ONX-F17 Section D-D
Bulkhead Position #4
Scale 1:4

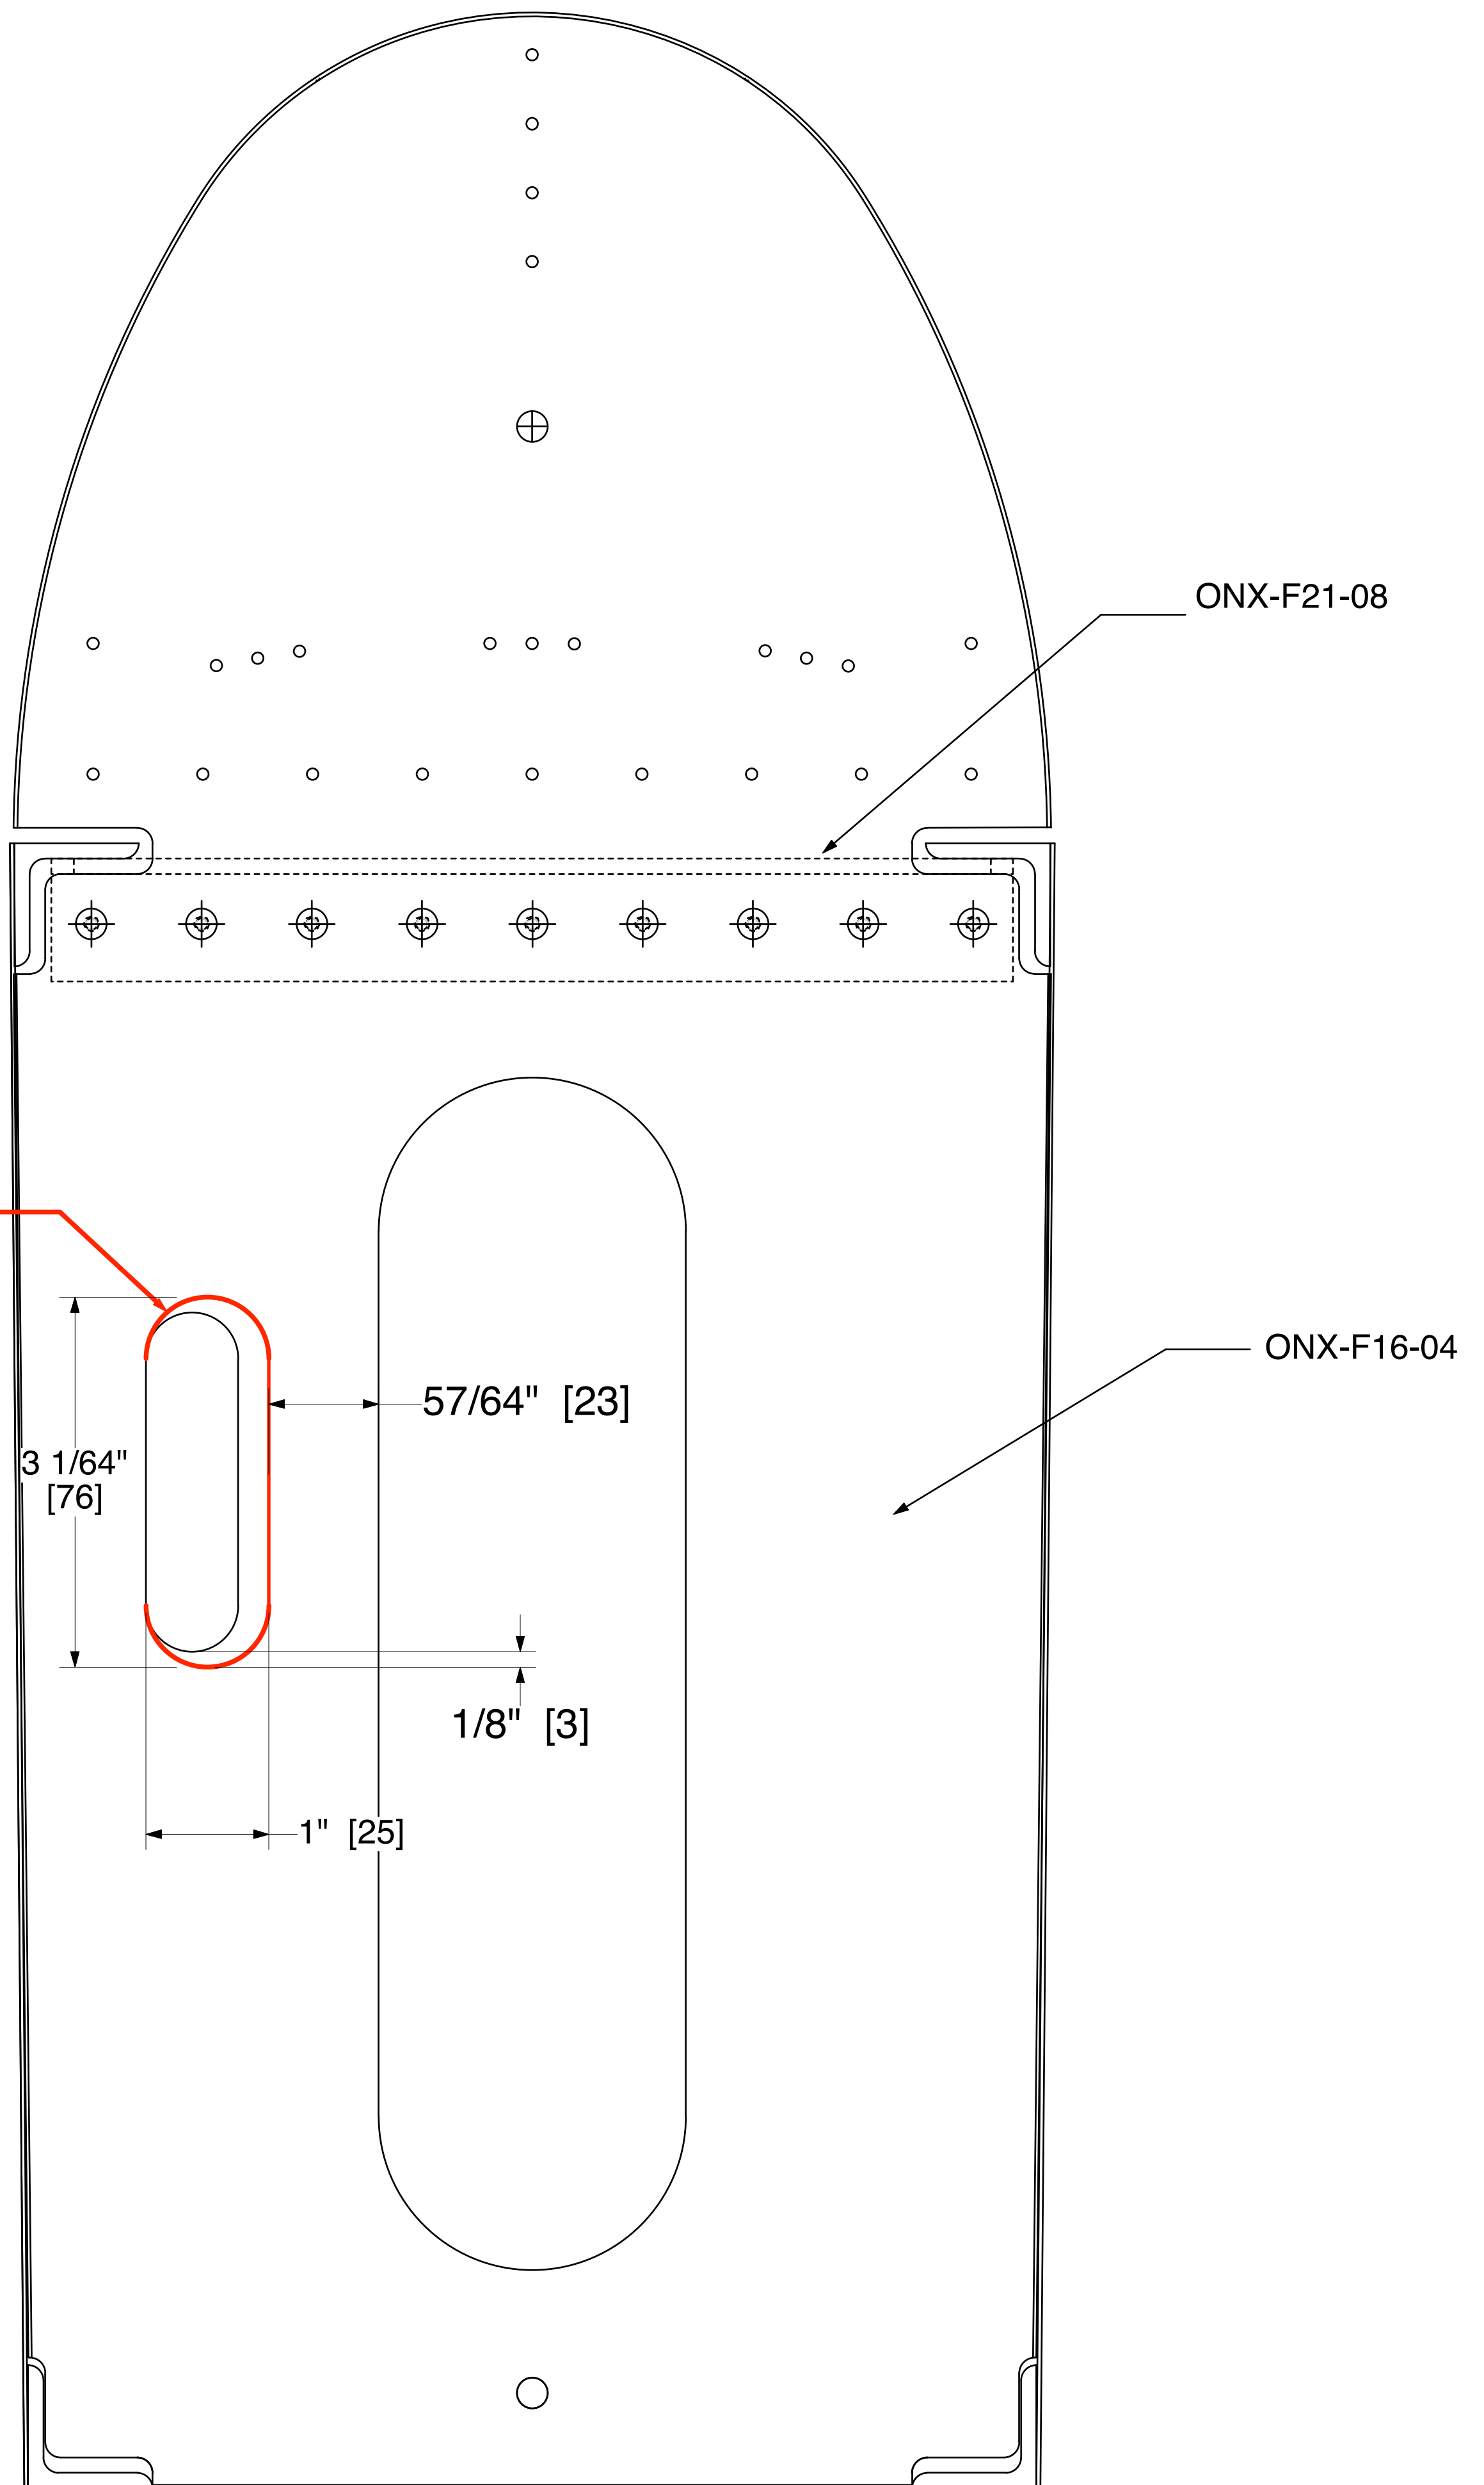
New Cutout
shape to allow
clearance with
elevator push rod
in full forward
and aft positions.
